Re: Avista Schedule 62 "Small Power Production and Cogeneration Schedule" Revisions  
Docket No. UE-210815

DOCKET NO. UE-210815

NORTHWEST & INTERMOUNTAIN  
POWER PRODUCERS COALITION’S  
AND RENEWABLE ENERGY  
COALITION COMMENTS

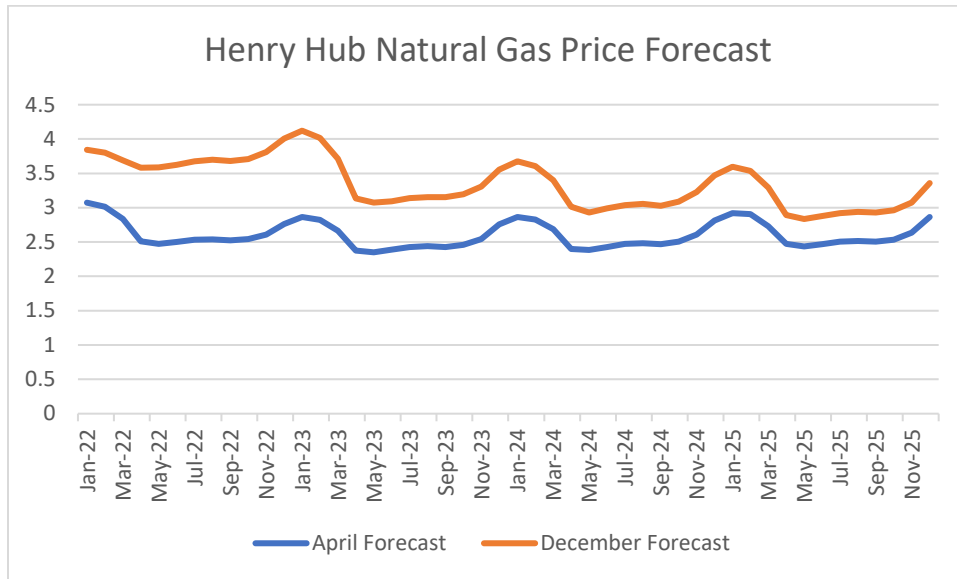
Avista's Schedule 62 energy rates are calculated based on the 2021 IRP Update Mid-C energy price forecast. This is an Aurora price forecast and takes gas market prices as an input. Electric prices are positively correlated with gas prices, with higher gas prices leading to higher energy prices. Natural gas futures prices have increased 15 to 45 percent since the 2021 IRP

Update was released in April 2021. The figure below compares the average closing price for Henry Hub natural gas futures traded on the New York Mercantile Exchange.<sup>55</sup> This increase should be reflected in the energy prices for Schedule 62.

NIPPC/REC recommends that Avista updates its Aurora forecast using 2021 IRP assumptions with gas prices replaced by current forward gas price curves. As an alternative, NIPPC/REC has prepared an adjusted Mid-C price forecast based on the difference between gas futures in April 2021 and December 2021 as of the date of drafting these comments.
